Right-Sized Alternatives to Eversource's planned X-178 115kV line complete rebuild:

Alternative #1:

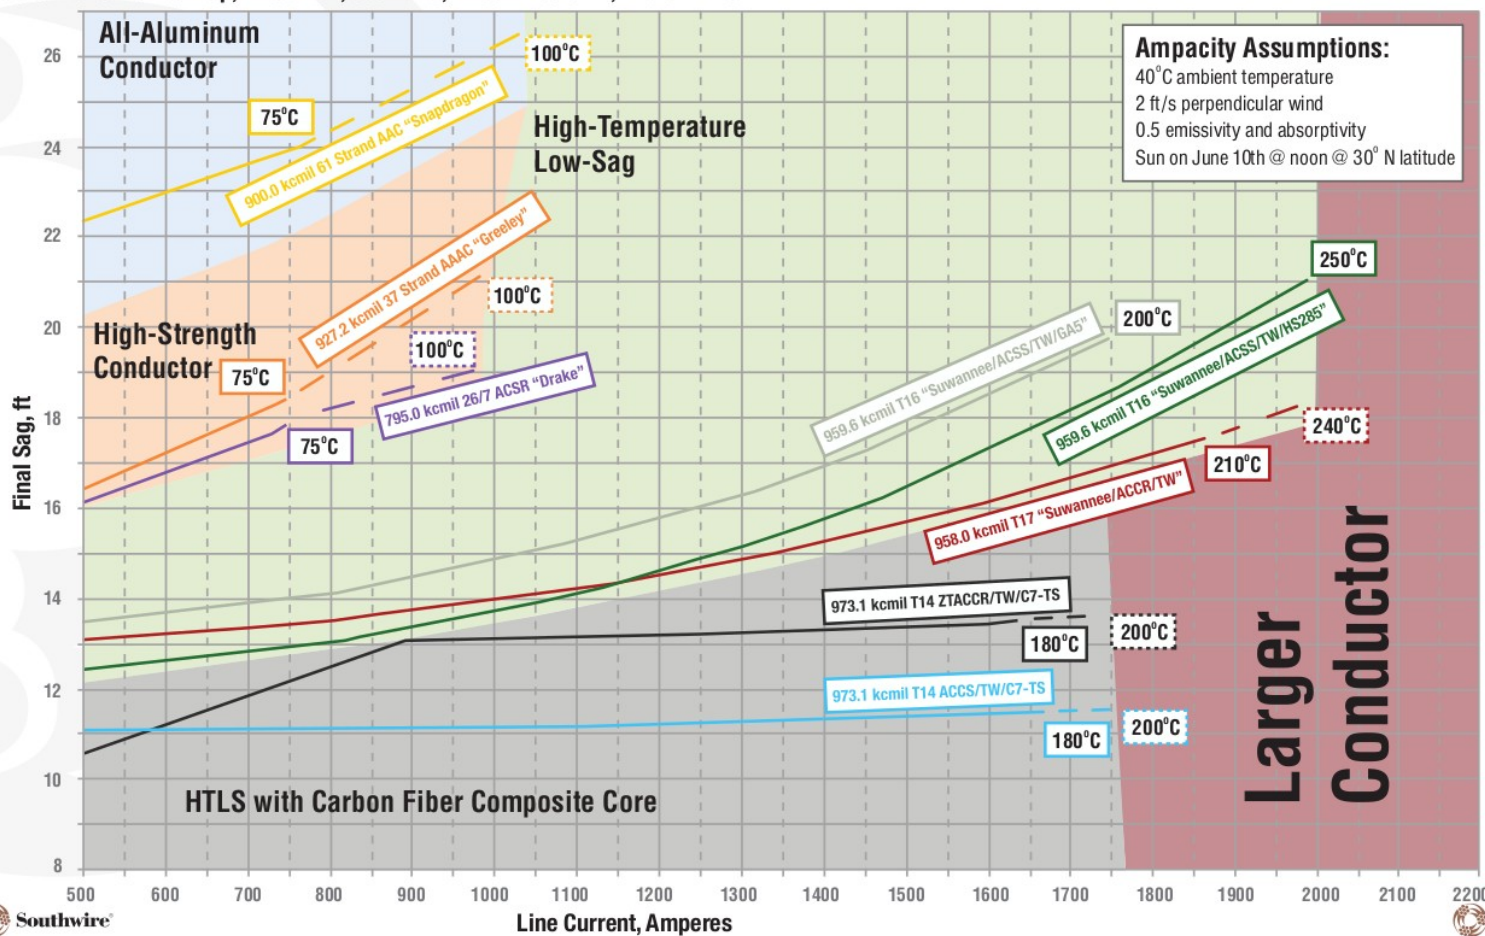
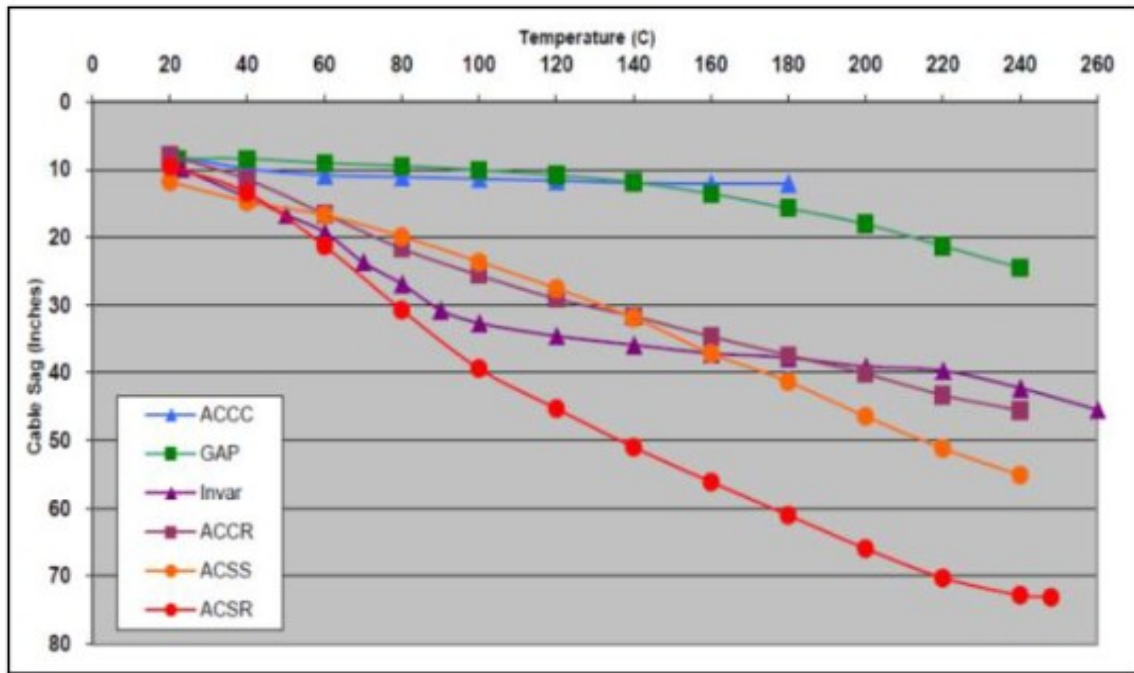
Note that the line clearances are calculated a 200 C, so the comparable sag of the ACCC and ACSS conductors at lower temps in the diagram below is irrelevant. The diagram below shows 956.6 kcmil ACSS/TW, which has less sag than the regular 1272 ACSS conductor Eversource has proposed for this project.
